In the Matter of
The Cincinnati Gas & Electric Company, et al.
(Wm. H. Zimmer Nuclear Power Station)

RE: Wm. H. Zimmer Nuclear Power Station, Unit 1 -
Request for Additional Information for Environmental Review
of Applicant's Request to Withdraw the Zimmer OL Application

CG&E RESPONSE TO NRC REQUEST FOR ADDITIONAL INFORMATION FOR
ENVIRONMENTAL REVIEW OF APPLICANT'S REQUEST TO WITHDRAW THE ZIMMER
OL APPLICATION

ENVIRONMENTAL REVIEW OF ZIMMER SITE STATUS
FOR THE CINCINNATI GAS & ELECTRIC COMPANY

Figures 3.9-1, 3.9-2

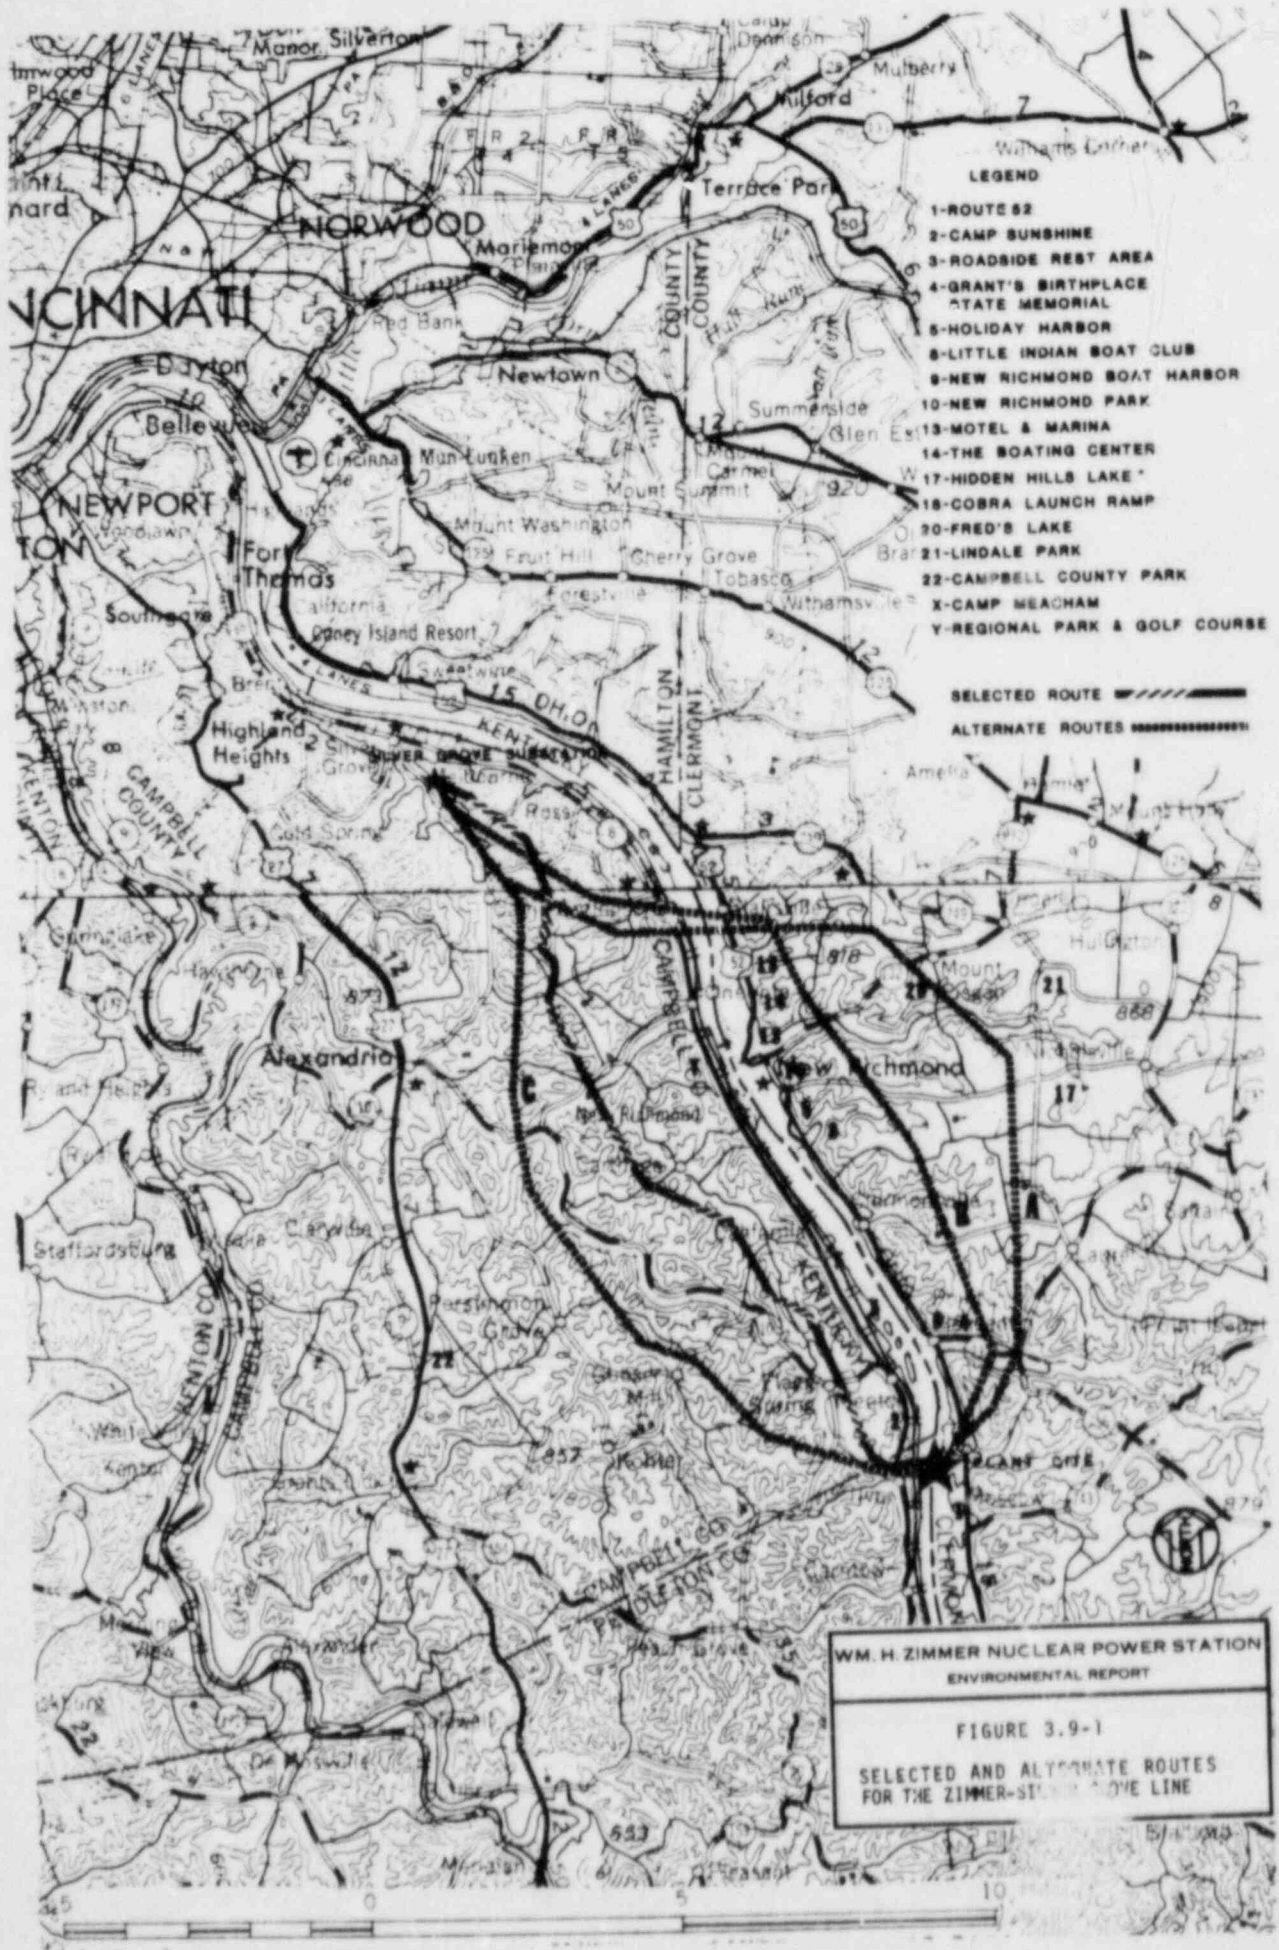
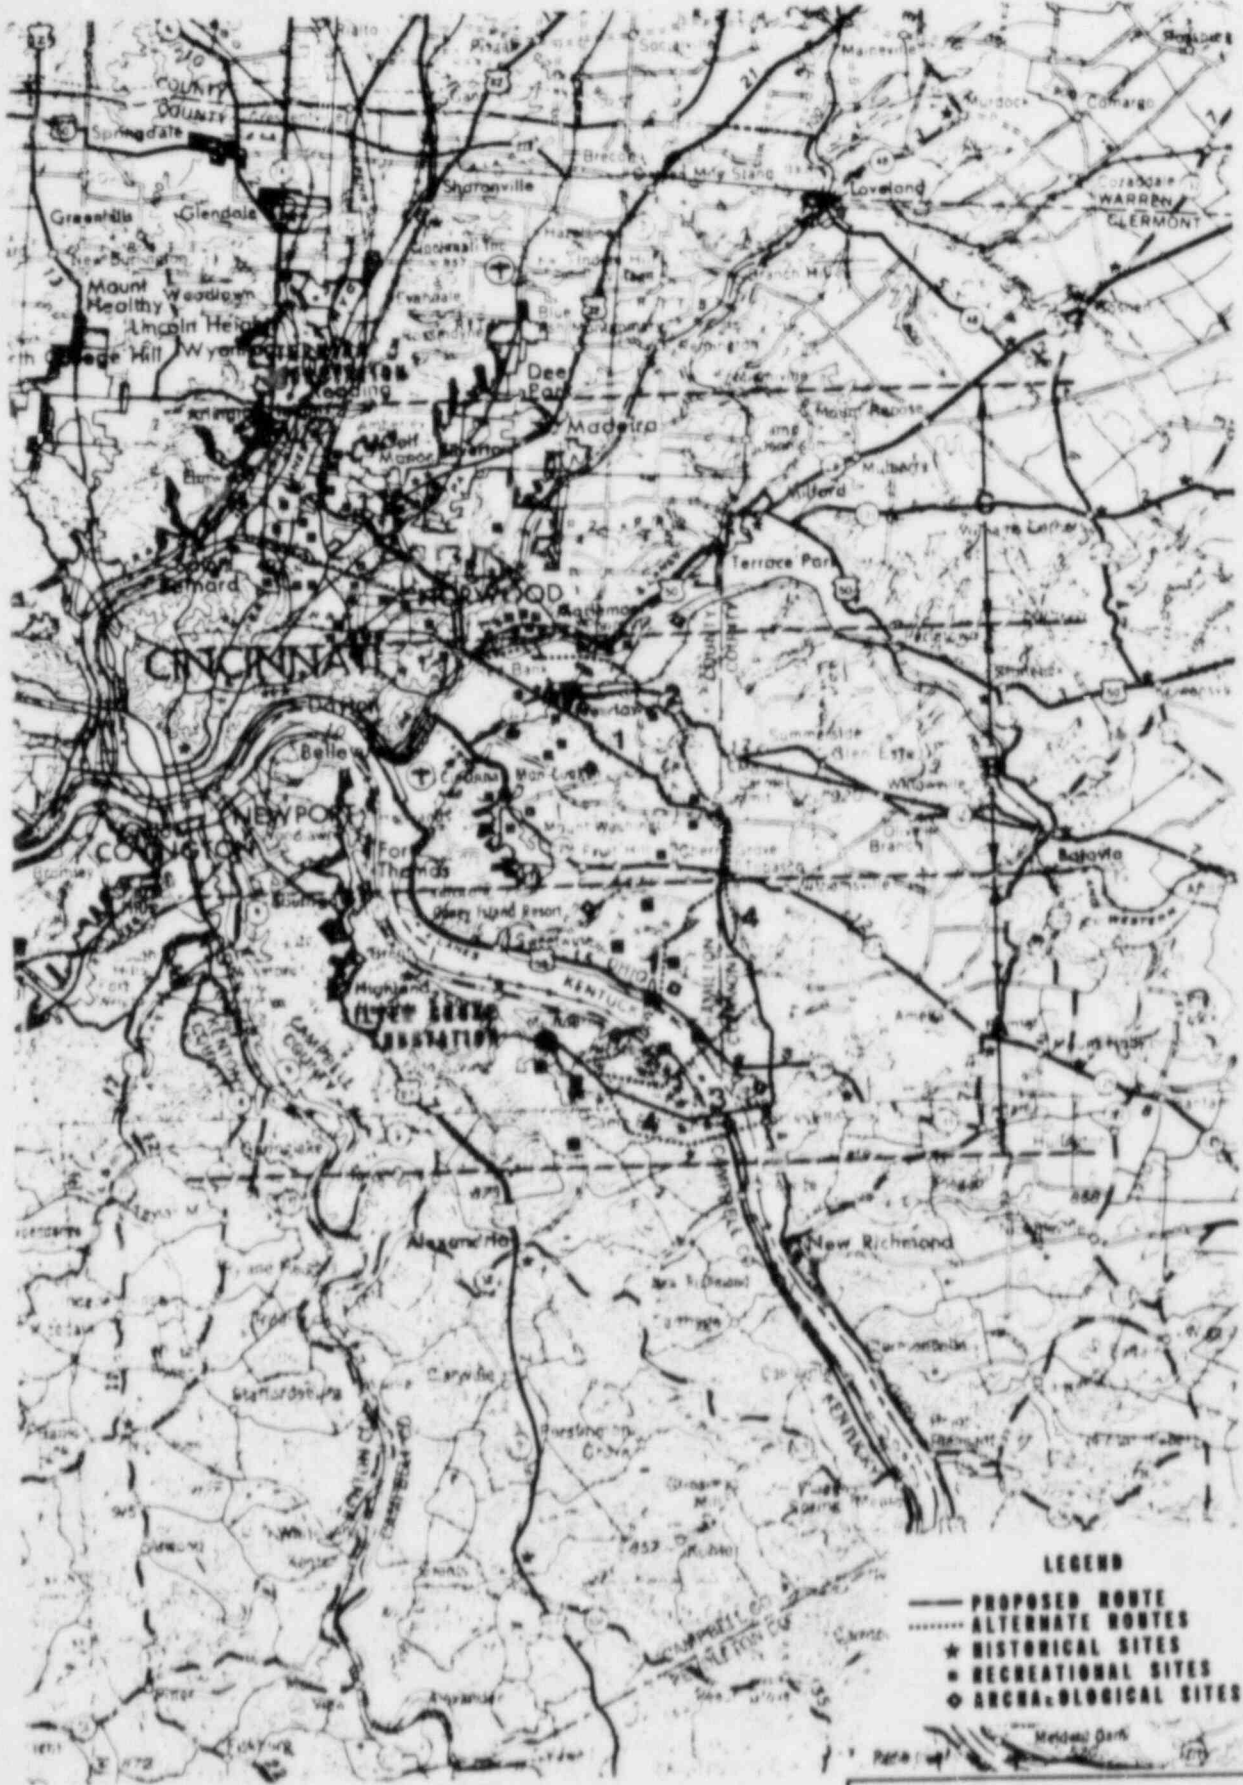
Provide a site plan showing areas (including transmission corridors) disturbed by construction-related activities. Identify the specific use of each disturbed area. Estimate acreage for each such disturbed area.

Maps showing transmission corridors associated with the Zimmer Station were previously submitted to NRC as Environmental Report-Operating License Stage (ER-OL) Figures 3.9.1 and 3.9.2. These figures have been reproduced and are provided as Appendix I to this report. Construction of these lines has been completed. The Zimmer-Silver Grove and Silver Grove - Terminal transmission lines were addressed in ER-OL, Section 9.1.
